Prospect - Timberline P.U.D., Preliminary Plan.
Proposal for a commercial P.U.D. zoned H-B,
Highway Business, at the northeast corner of
East Prospect Street and Timberline Road.

PROSPECT - TIMBERLINE SUBDIVISION

PROSPECT TIMBERLINE SUBDIVISION - 1ST FILING

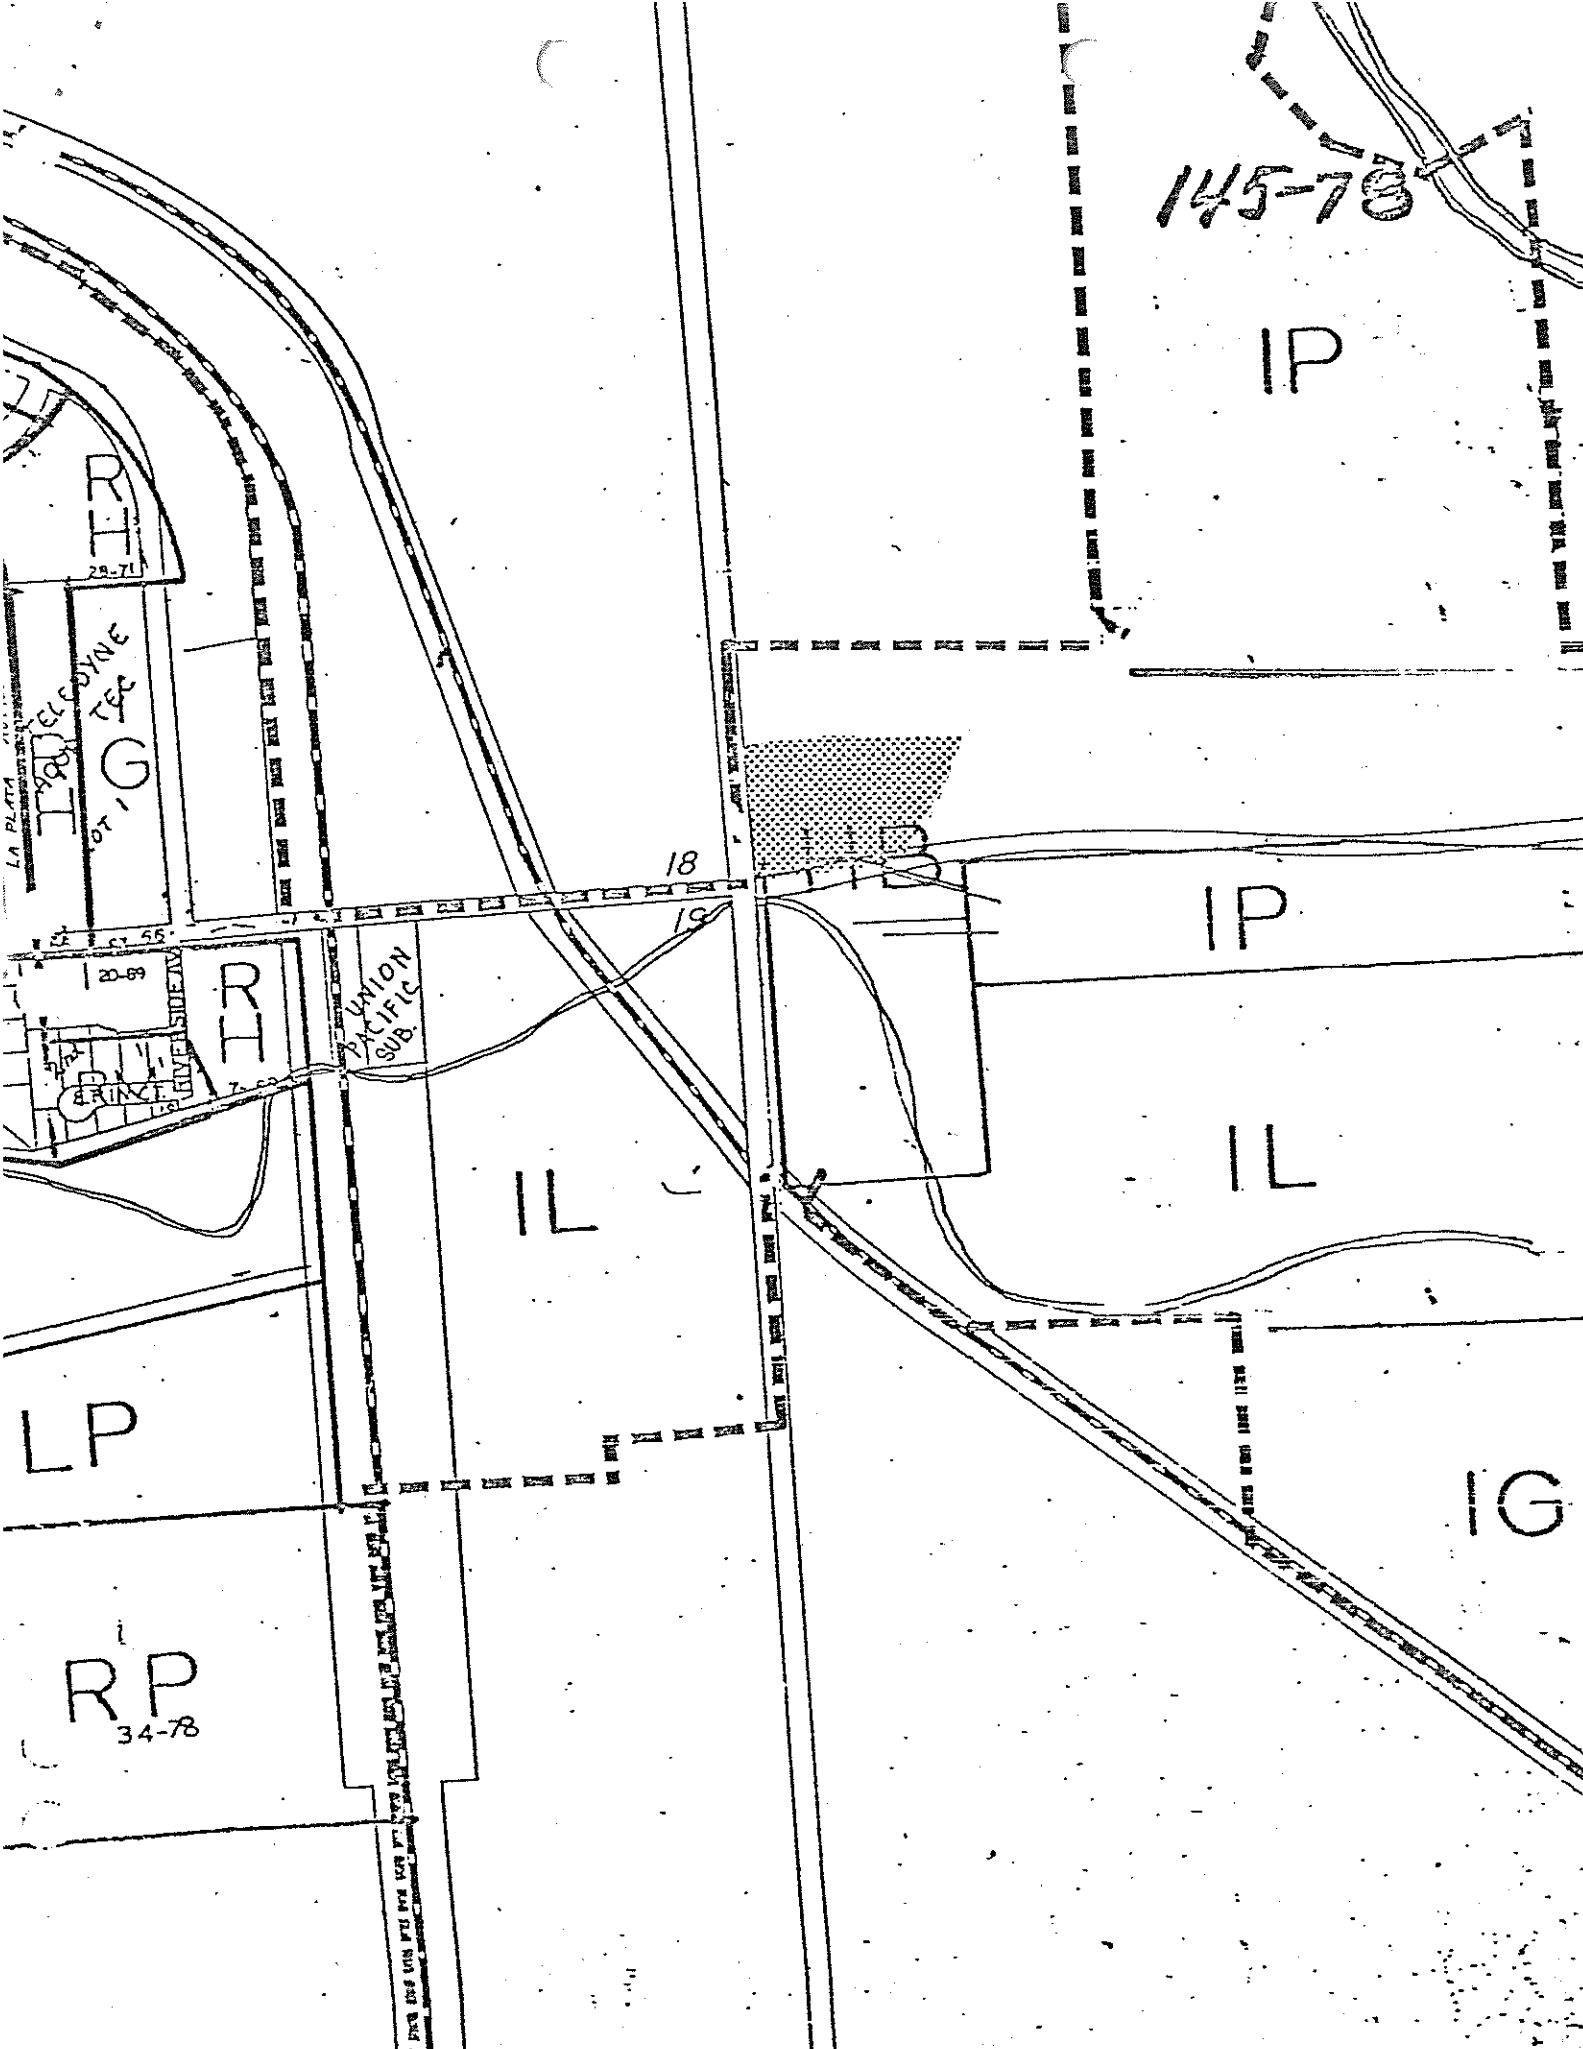
- ✓ 1. Change "Director of Engineering Services" to "Director of Public Works"
- ✓ 2. ISN'T THIS a PUD ?
- ✓ 3. PLAT SHOULD ~~HERE~~ INCLUDE 1/2 SPRING CREEK AND RECREATIONAL TRAIL EASEMENTS.
- ? 4. Delineate Flood Plain from FIA Report.

Sheet 2 of 3

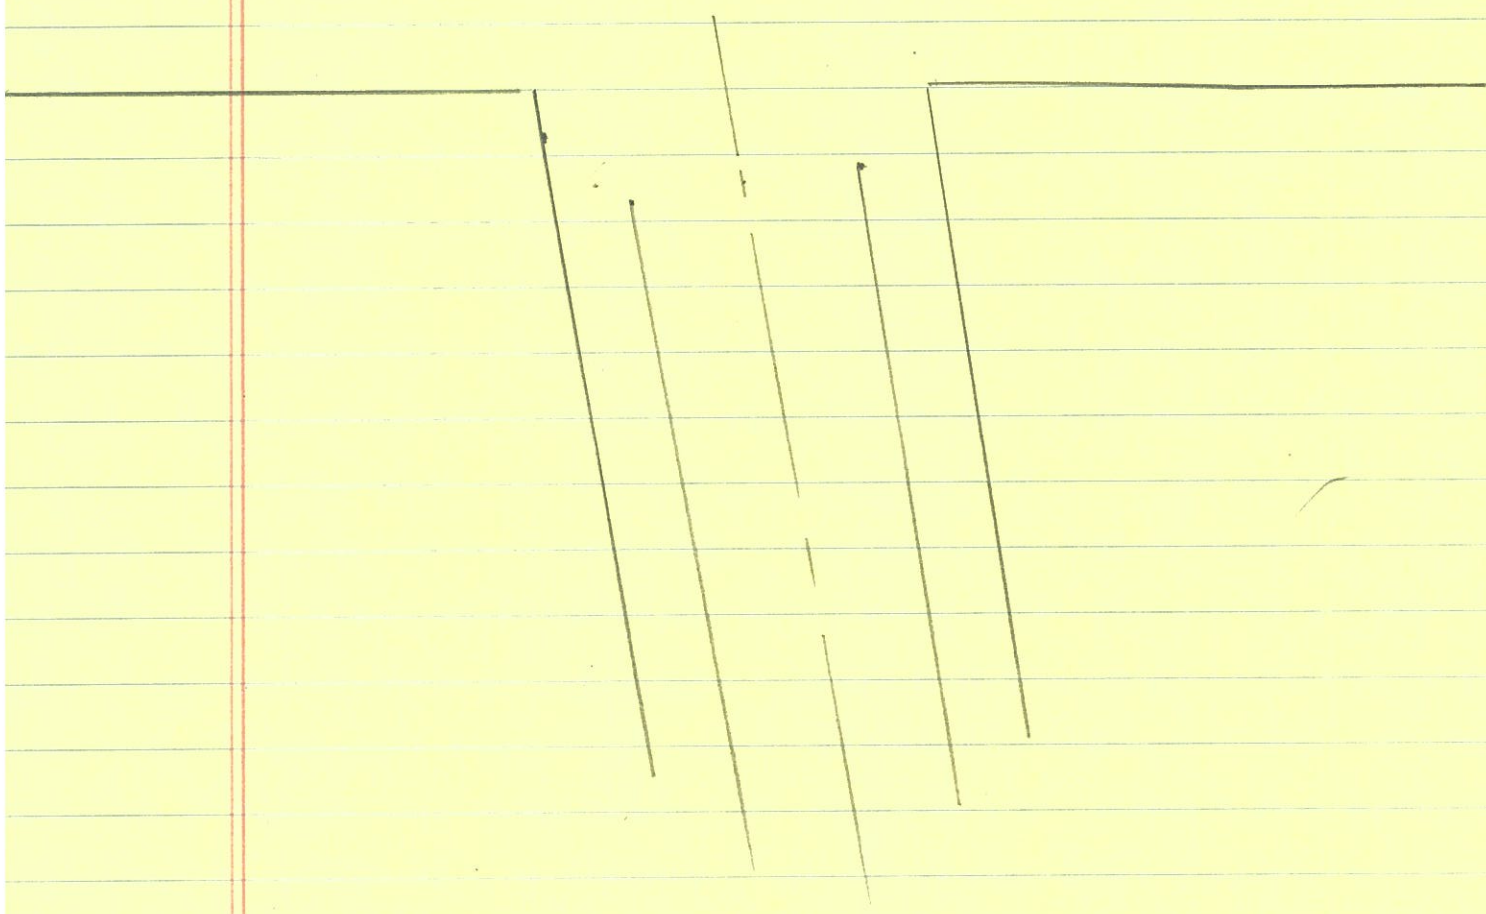
- ✓ 1. No curb cut note on Timberline NONE PROVIDED
- ✓ 2. curb cut location for Prospect St.
- 27 } OR
65 } OVERLAY
65 } OF EXIST
3. WHERE IS Soils Test TO VERIFY STREET DESIGN (The centerpoint test is for the main Street (Midpoint Rd) WHICH IS 6-700' South of this location.)
- DONE } ~~Suggest~~ Cores of Prospect and Timberline (one each) at DEVELOPER'S Expense
- ✓ 4. Add fire hydrant @ East end of Subd. including valve & Tee.
- ✓ 5. North Arrow
